# Access Compliance Report

## Public Rights-of-Way

### (Curb Ramps)

Intersection ID: 13667	Main Street: E_7TH_ST	Cross Street: HAWTHORNE_LN	Location: E
ADA ID: C10C61299D95	Ramp Type: PerpDiag	Initial Pass/Fail: Fail	Overall Compliance: No
Severity Score: 12.5			
Codes/Mitigation Info/Possible Solution		Field Measurements/Component Compliance

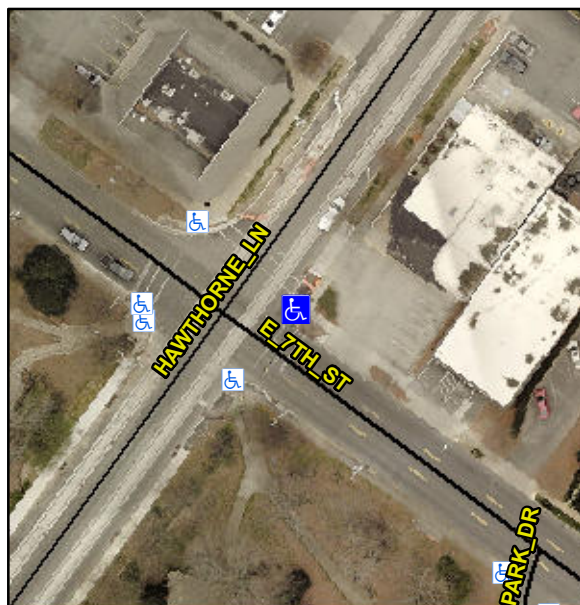
**Not Found, R304.2.2**

Compliance	Description	Data	Compliance	Description	Data
N/A	Ramp Length (in)	53.0	No	Ramp Slope (%)	10.1
Yes	Ramp Width (in)	48.0	Yes	Ramp XSlope (%)	1.8
N/A	Flare Type LT	N/A	N/A	Flare Type RT	N/A
N/A	Flare Slope LT (%)	N/A	N/A	Flare Slope RT (%)	N/A
N/A	Flare Traversable LT?	N/A	N/A	Flare Traversable RT?	N/A
N/A	Landing Length (in)	N/A	N/A	DWS Provided?	N/A
N/A	Landing Width (in)	N/A	N/A	DWS Contrast?	N/A
N/A	Landing Slope (%)	N/A	N/A	DWS Length (in)	N/A
N/A	Landing X Slope (%)	N/A	N/A	DWS Full Width?	N/A
N/A	Landing Curb? (Y/N)	N/A	N/A	DWS Offset (in)	N/A
N/A	Shared Landing?	N/A			
N/A	Gutter Ponding?	N/A	N/A	Gutter Slope (%)	N/A
N/A	Gutter Lip Ht (in)	N/A	N/A	Gutter X Slope (%)	N/A
N/A	Painted X Walk1?	Yes	N/A	Painted X Walk2?	Yes
	X Walk 1 Direction	To NW		X Walk 2 Direction	To SW
N/A	X Walk 1 Width (in)	75.0	N/A	X Walk 2 Width (in)	97.0
	X Walk 1 Slope (%)	3.1		X Walk 2 Slope (%)	3.3
	X Walk 1 X Slope (%)	0.1		X Walk 2 X Slope (%)	2.3

**Remove & Replace Curb Ramp With Two New Directional Ramps or Equivalent.**
